EAST ROSWELL LIBRARY
ADDENDUM NO. 23.1-3
APRIL 25, 2013
PAGE 1 OF 1

This Addendum No. 23.1-3 dated April 25, 2013 issued by Ajax Building Corporation of Georgia is hereby made part of Bid Package 23.1 – HVAC & CONTROLS for the East Roswell Library. The changes and/or clarifications included in this Addendum shall be considered as part of the Bidding Documents and shall supersede, amend, add to, or subtract from those conditions included in the original Bidding Documents, including the Project Bid Package, Drawings, Specifications, previous Addenda, etc. This Addendum must be acknowledged in the space provided on the Proposal Form (included in Section II of the Bid Package). Failure to acknowledge this Addendum may subject Bidder to disqualification.

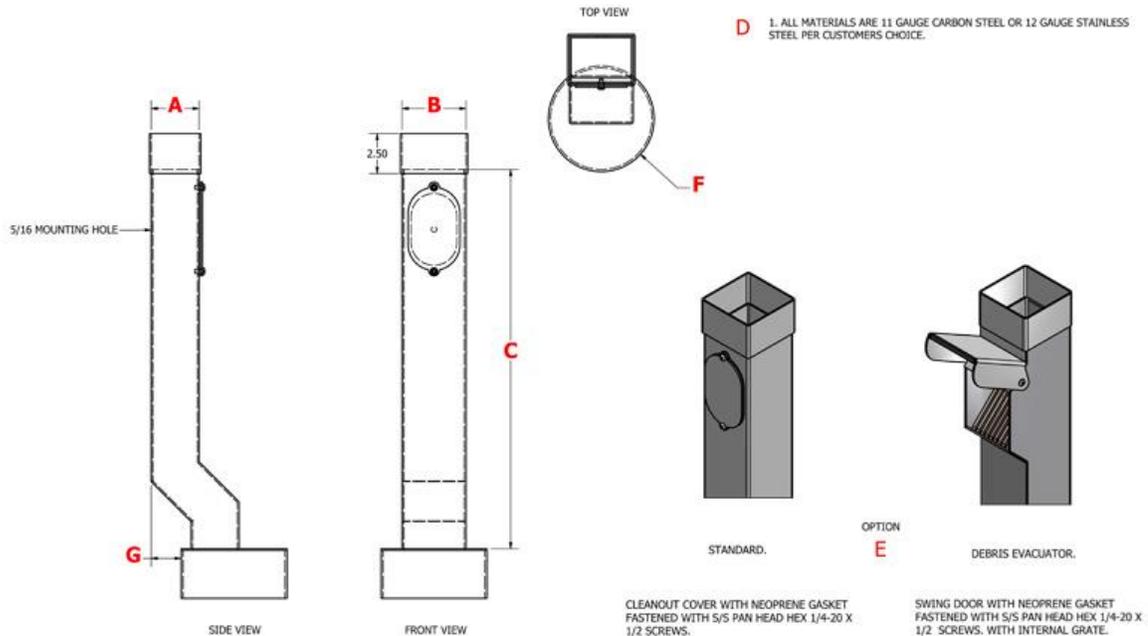
Please provide Body Length and Offset Size for downspout boots.

Receiver's Reply: Piedmont Pipe Downspout - Model SO

- A: To Receive 8” Diameter OD Downspout
- B: To Receive 8” Diameter OD Downspout
- C: 24”
- D: 304 Carbon Steel with Manufacturer’s standard black finish
- E: Standard Cleanout
- F: To connect to 8” Storm drain
- G: 4” off set
